Panel Reference	2018SCL035
DA Number	DA201800173
LGA	Inner West
Proposed Development	Demolish existing structures and construct 'staged' development over three (3) sites. The proposal includes 357 apartments, a registered club with ancillary uses and a food and drink premises. A new through-site link connecting Regent Street to Fozzard Lane is also proposed.
Street Address	3-7 & 13-17 Regent Street. 287-309 Trafalgar Street & 16-20 Fisher Street Petersham
Applicant/Owner	DEICORP PROJECTS PETERSHAM PTY LTD
Date of DA lodgement	16 April 2018
Number of Submissions	179 total
Recommendation	Deferred Commencement
Regional Development Criteria (Schedule 7 of the SEPP (State and Regional Development) 2011)	Capital investment value of \$132,564,080
List of all relevant s4.15(1)(a) matters	State Environmental Planning Policy No. 55 – Remediation of Land State Environmental Planning Policy (Infrastructure) 2007 State Environmental Planning Policy No 65 —Design Quality of Residential Apartment Development State Environmental Planning Policy (Building Sustainability Index: BASIX) 2004 Commonwealth Airports (Protection of Airspace) Regulations 1996 Civil Aviation Regulations 1988 Roads Act 1993

Figure 7: Waste collection point for Site 1.

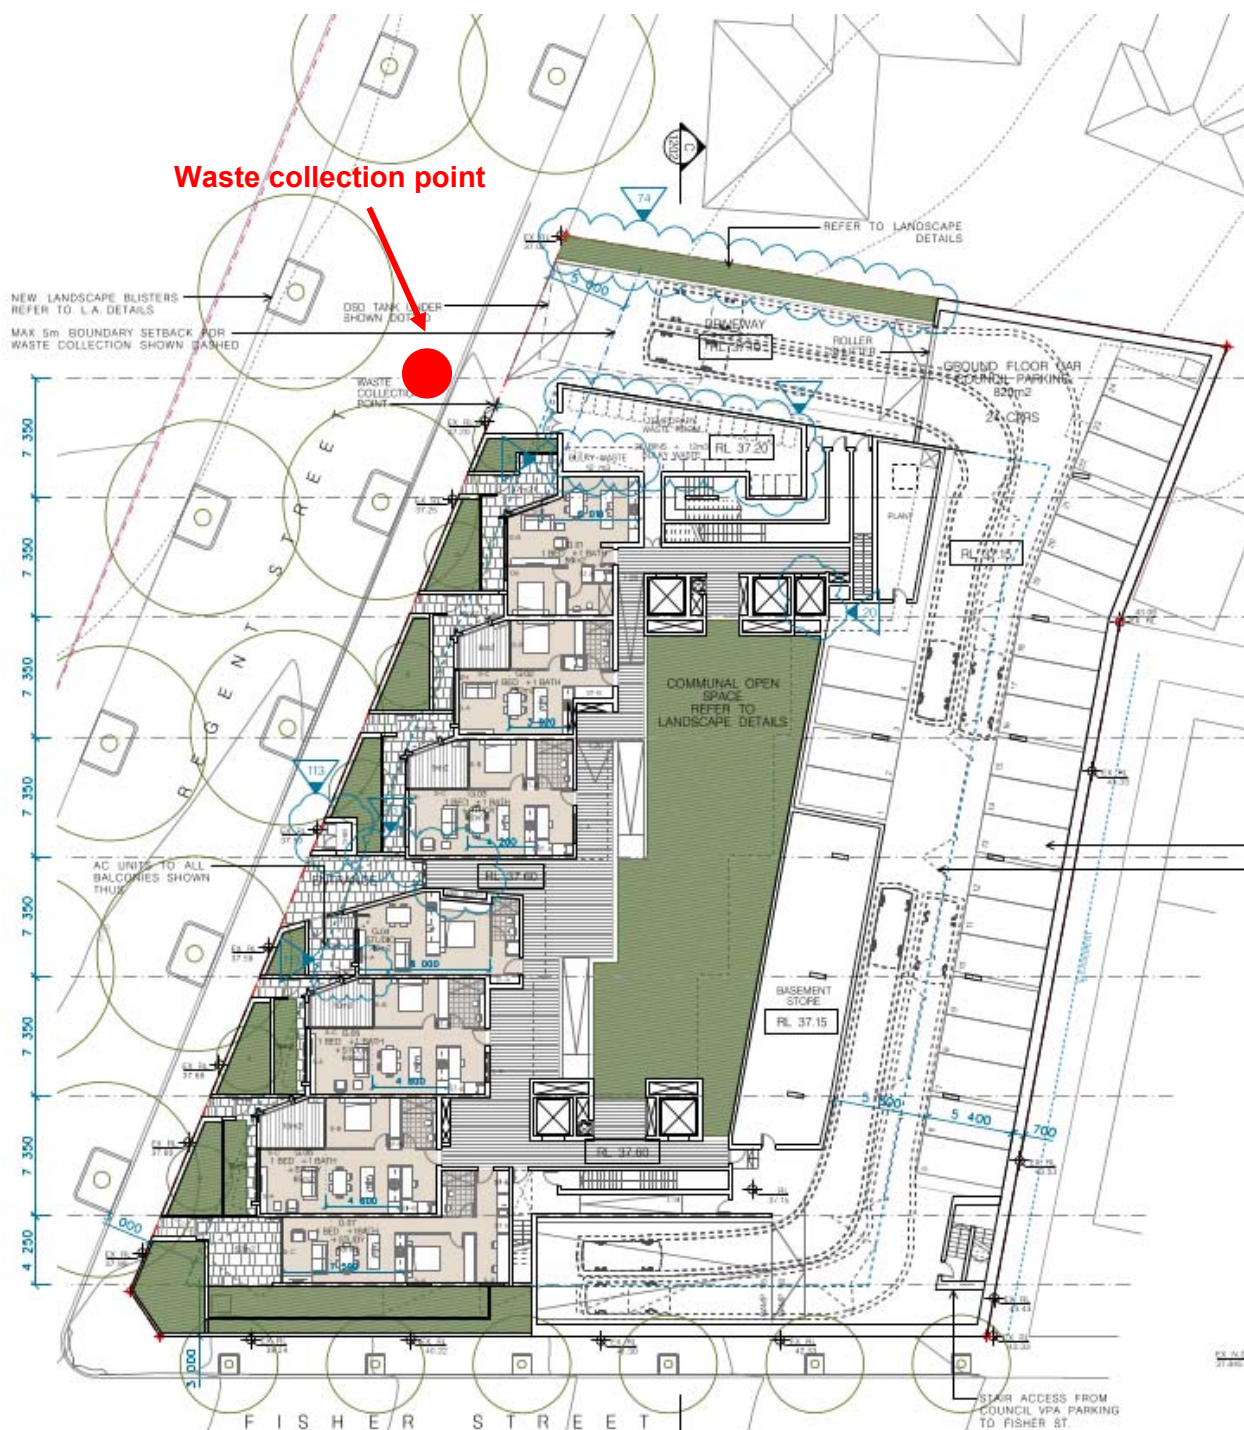
Waste is proposed to be collected on Regent Street for Site 1. A temporary waste storage area is included immediately adjacent to the waste collection point (see Figure 7).

Figure 8: Waste collection point for Site 2.

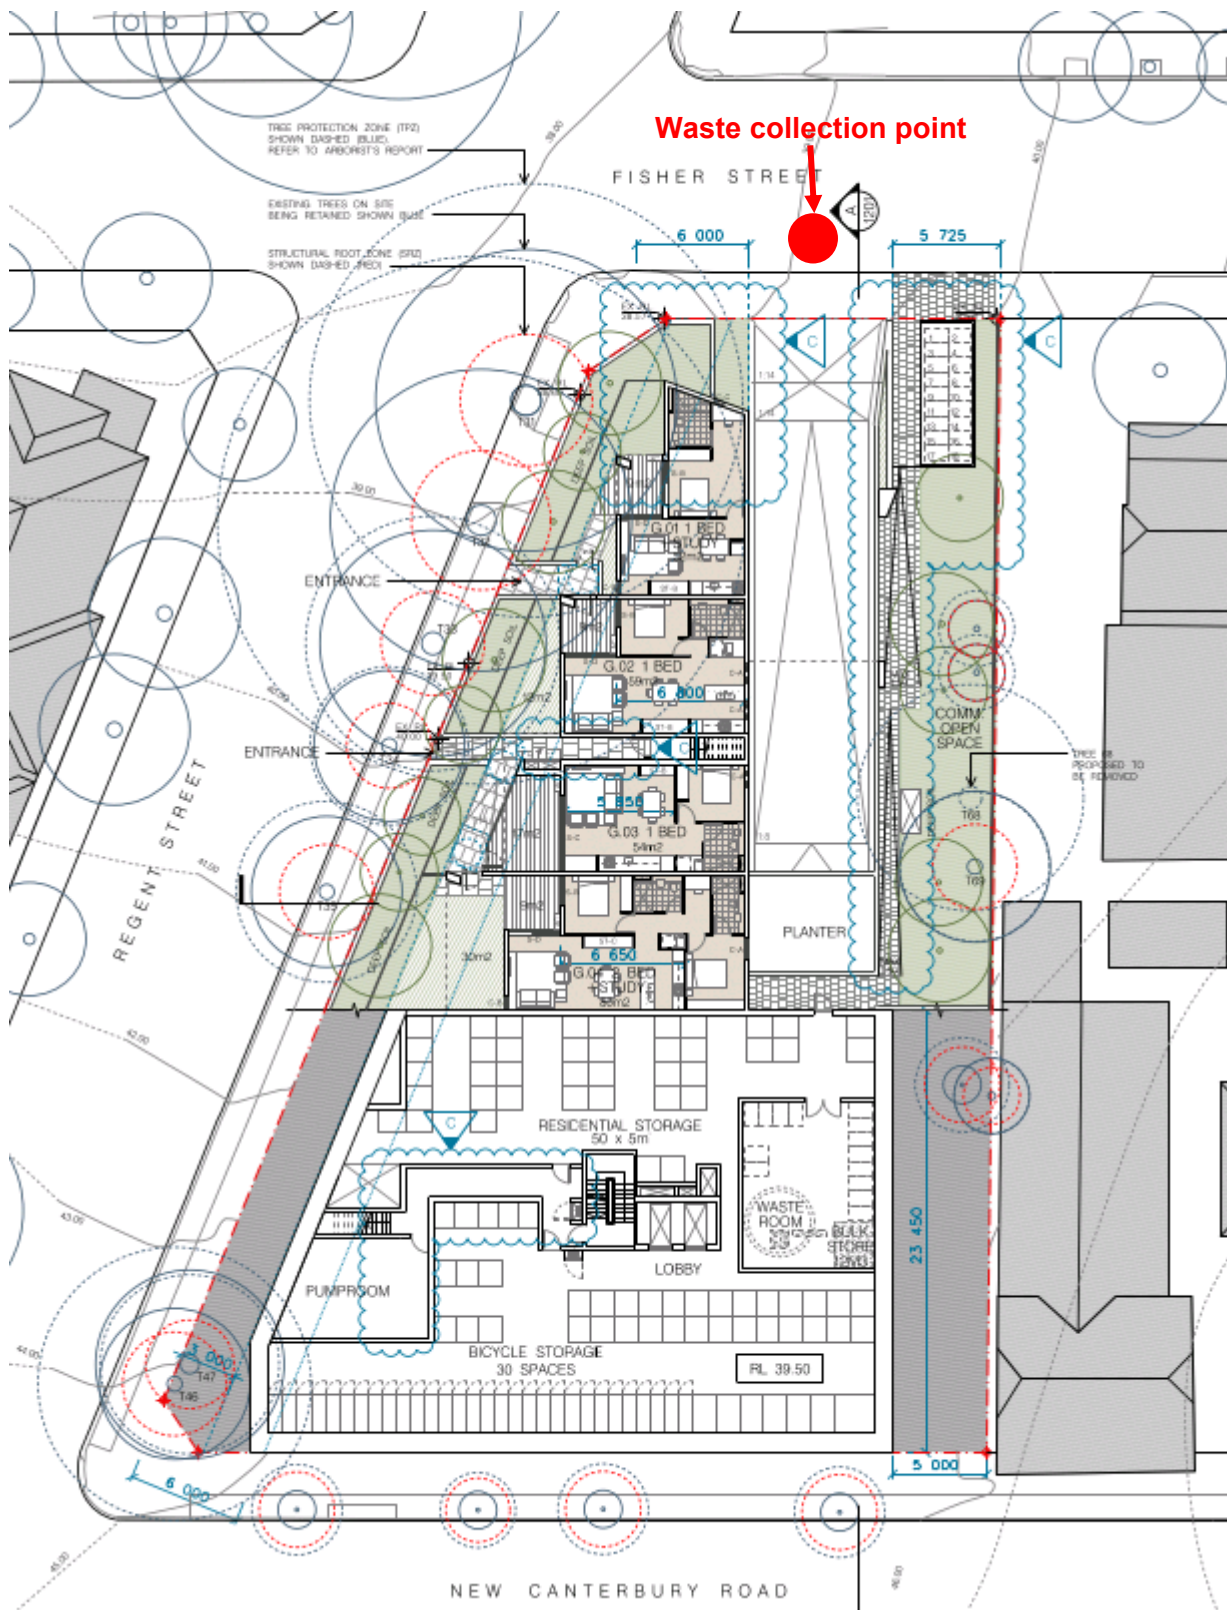
Waste is proposed to be collected on Fisher Street for Site 2 (see Figure 8). A temporary waste storage area is included immediately adjacent to the waste collection point. There is a possible conflict of the proposed waste collection point which would require waste collection trucks to obstruct the subject sites driveway and possibly the neighbouring properties driveway during collection. The applicant has stated that the waste collection point could be relocated to Regent Street and initial sketches have been provided however Council has raised initial concerns given the uncertainty of a suitable location for a temporary waste collection area and the amenity impacts on the nearby units, particularly at ground level. It is a recommended deferred commencement

condition that waste collection be explored on the Regent Street frontage to the satisfaction of Council.

Figure 9: Waste collection point for Site 3.

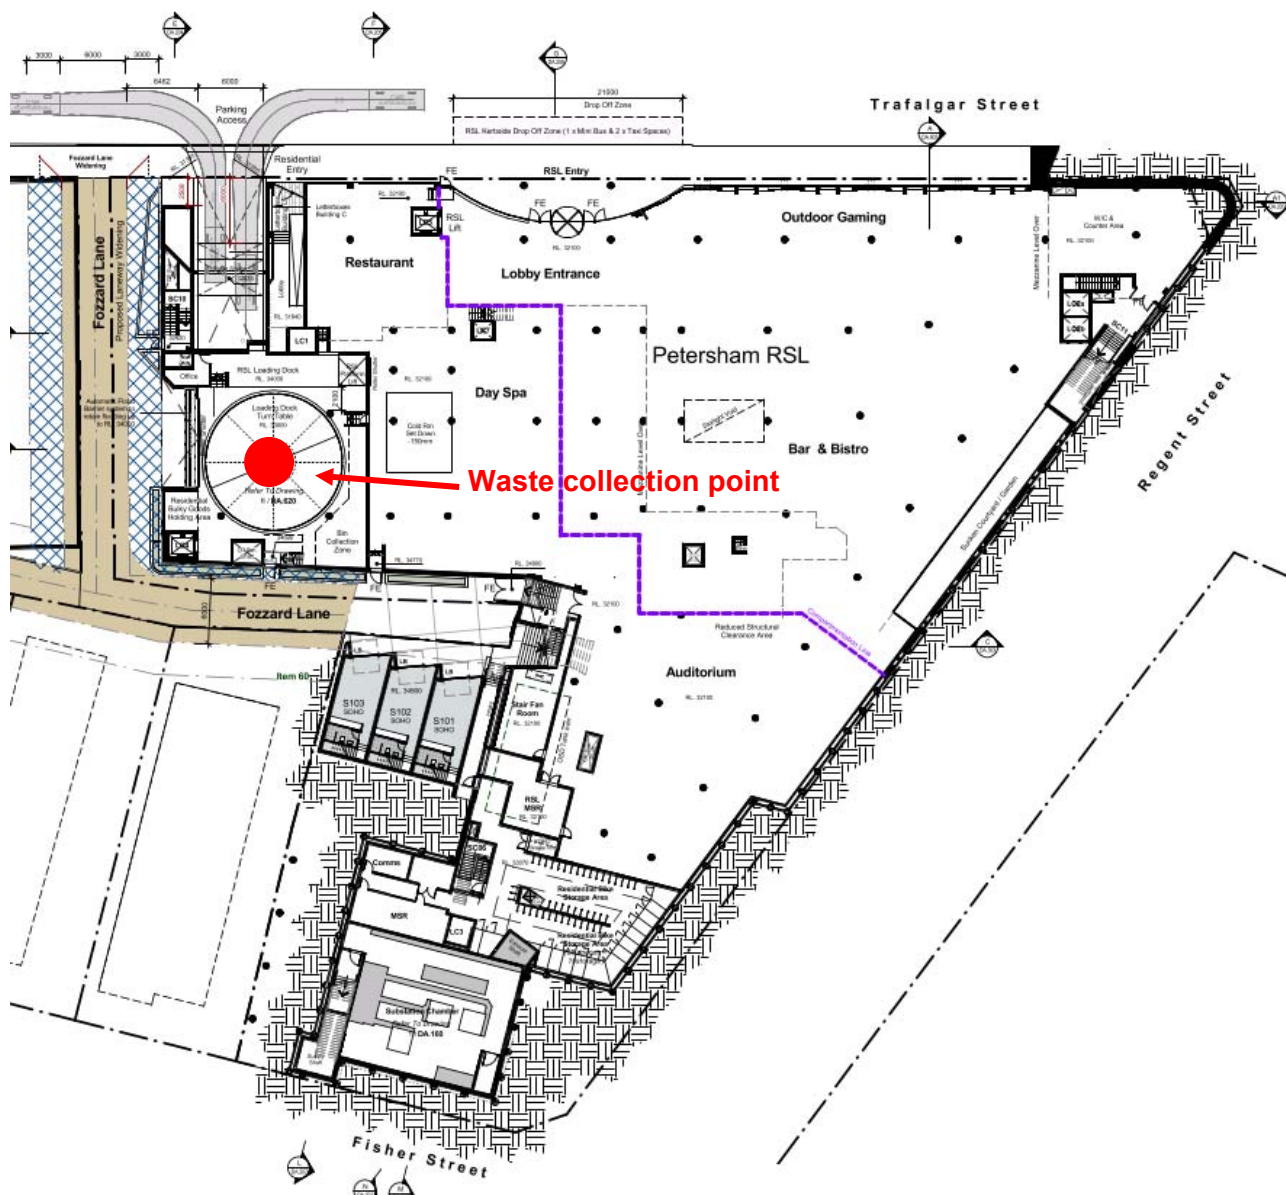
Waste is collected on Site 3 within the loading dock which is accessed from Fozzard Lane (see Figure 9). The loading dock includes a turntable which allows waste collection vehicles to enter and exit the site in a forward direction.
